147. Physical Coding Sublayer (PCS), Physical Medium Attachment (PMA) sublayer and baseband medium, type 10BASE-T1S

(edits only shown, and indicated in red)

Figure 147-2—10BASE-T1S PHY interfaces

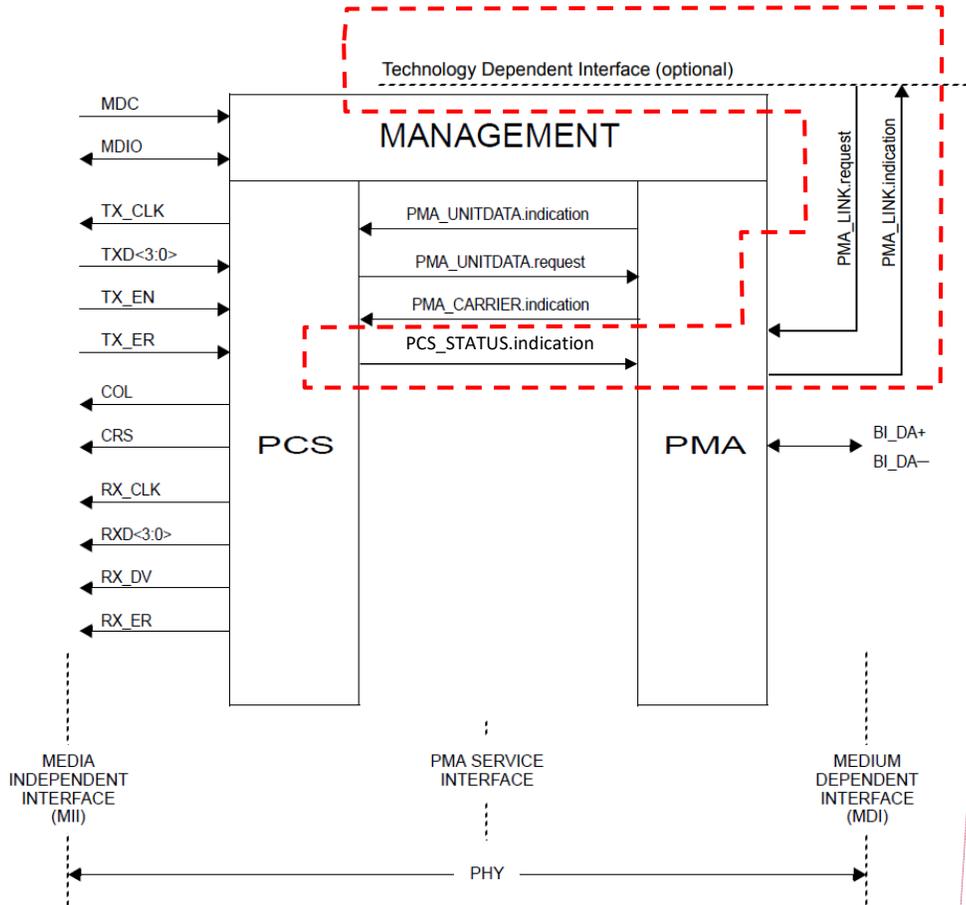
Change Figure 147-2 as shown (red dashed boxes indicate changes – these are not intended for the final figure):

Commented [PB1]: Add PCS_STATUS.indication primitive (marked in red)
 Add Technology Dependent Interface
 Add PMA_LINK.request
 Add PMA_LINK.indication

Figure 147-3—PCS reference diagram

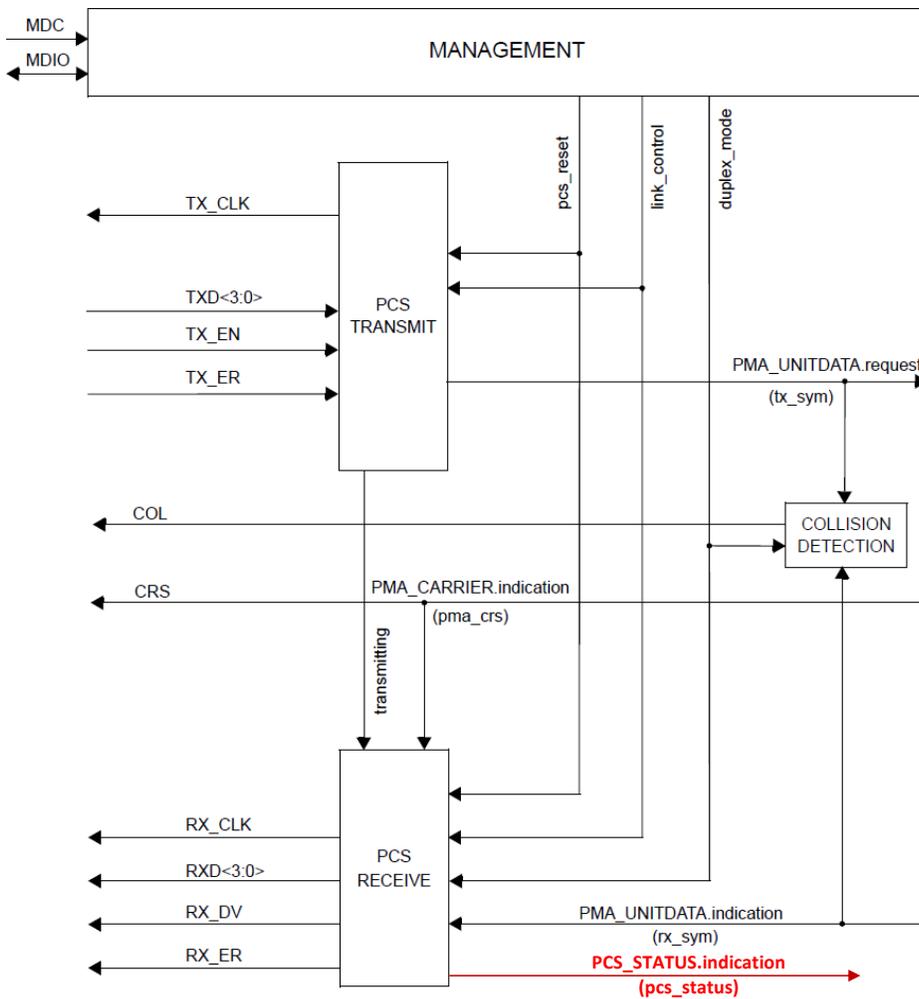
Change Figure 147-3 to add PCS_STATUS.indication primitive as shown (changes in red):

Commented [PB9]: Add PCS_STATUS primitive (marked in red)

Figure 147-TBD: HB Transmit State Diagram (part a)

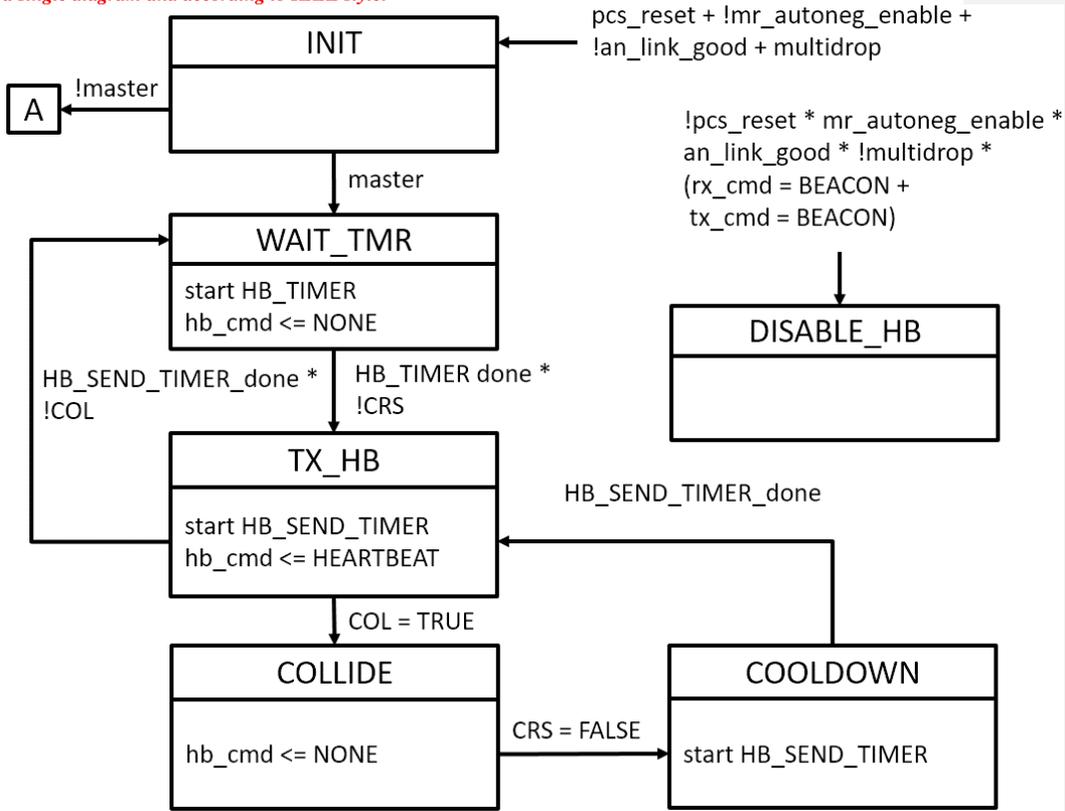
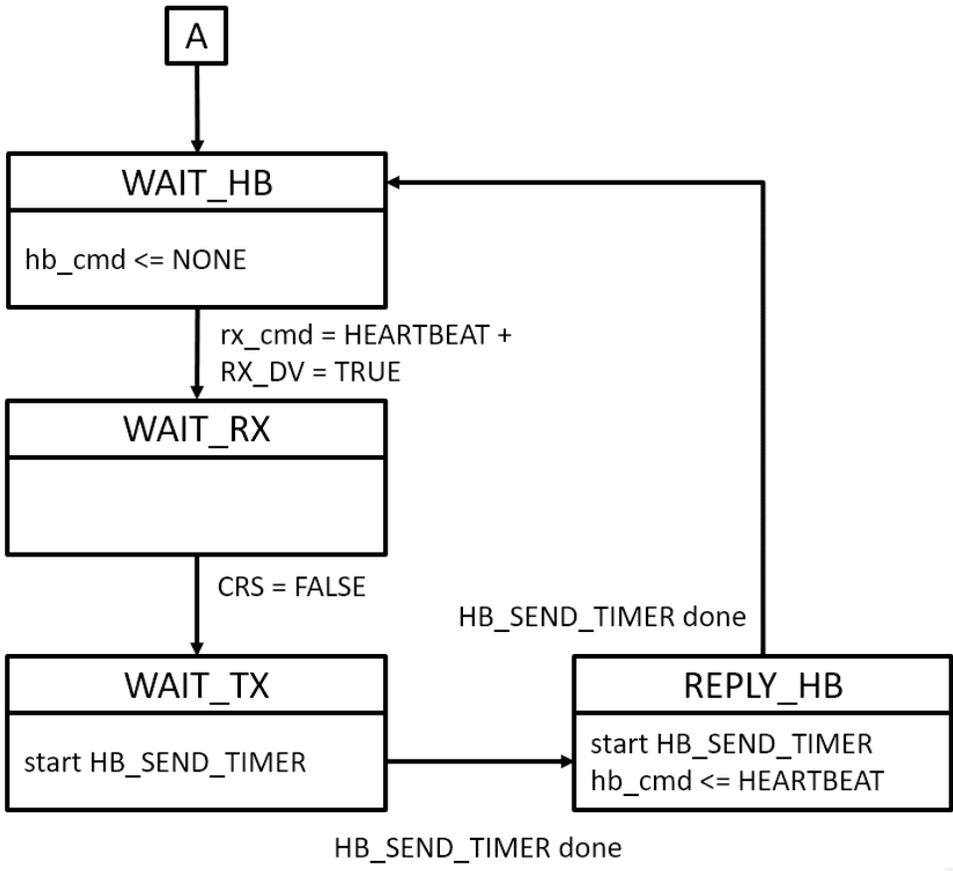
Insert Figure 147-TBD Heartbeat transmit state diagram with editorial license to combine parts a & b below into a single diagram and according to IEEE style.

Figure 147-TBD: HB Receive State Diagram

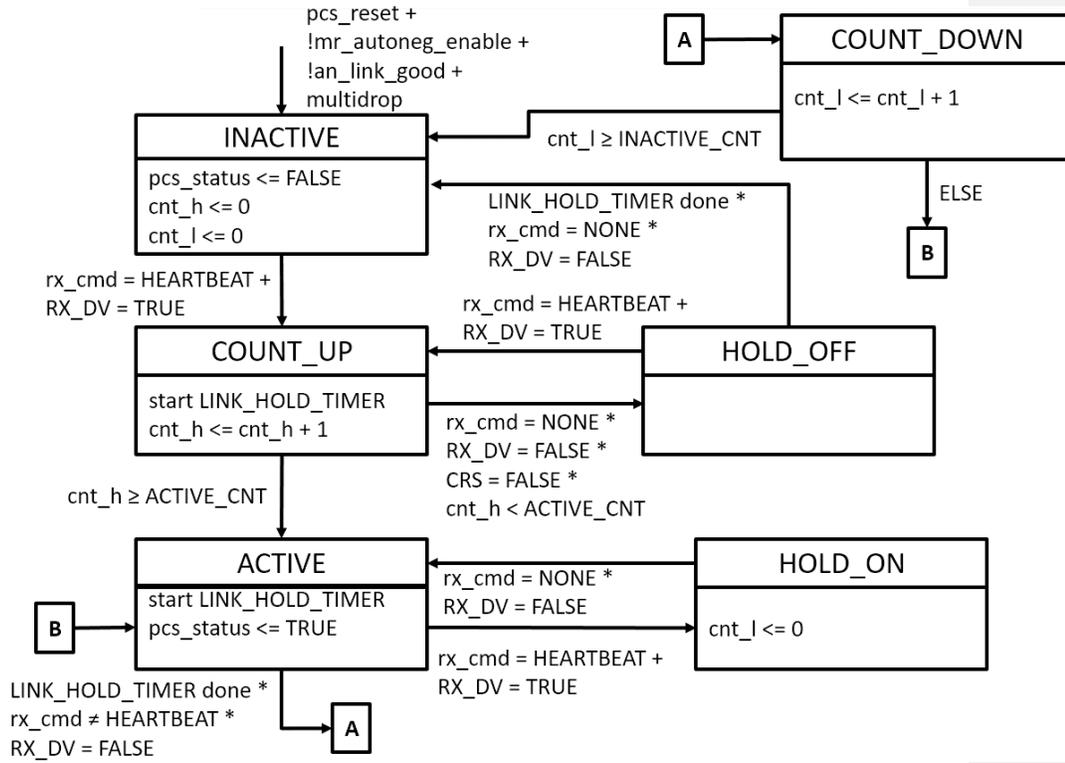
Insert Figure 147-TBD Heartbeat receive state diagram with editorial license to redraw according to IEEE style.

Figure 147-10—PMA functional block diagram

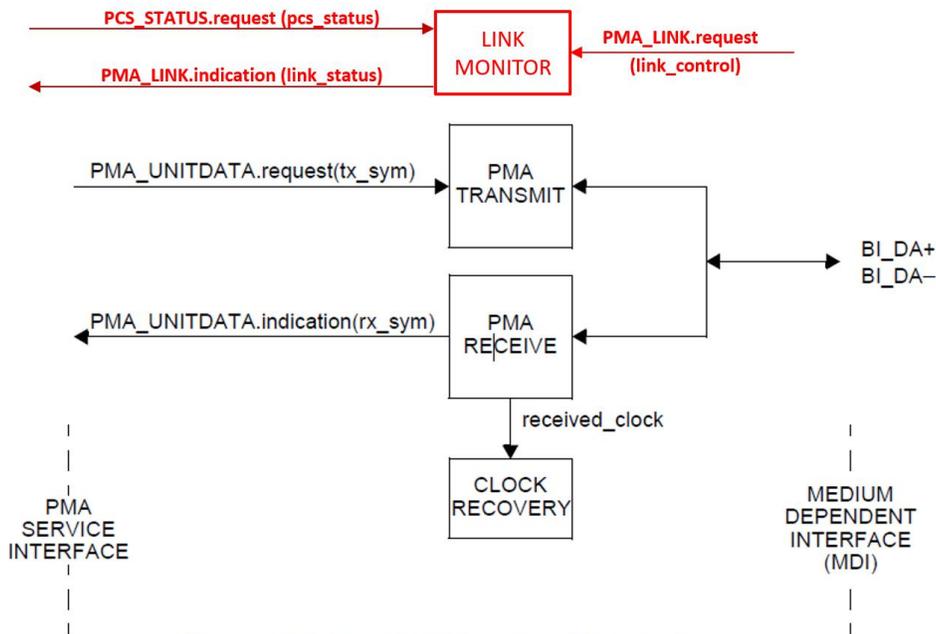
Change Figure 147-10 to add LINK MONITOR and primitives as shown (changes in red):

Commented [PB15]: Add Link Monitor block and related primitives in the figure

Figure 147-TBD: Link Monitor State Diagram

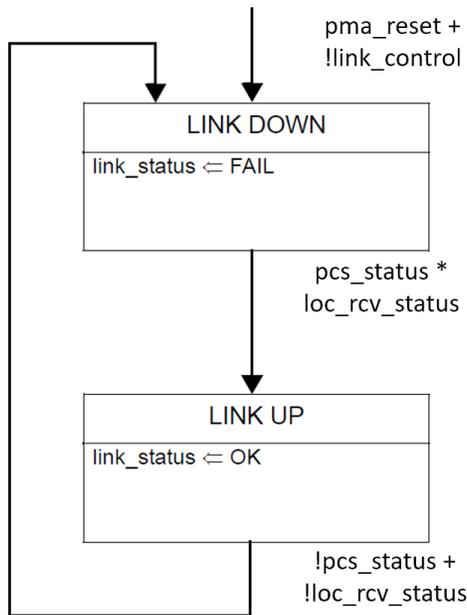
The PMA shall conform to the Link Monitor State diagram in Figure 147-[TBD] and associated variables.

Commented [PB17]: reference to link monitor state diagram
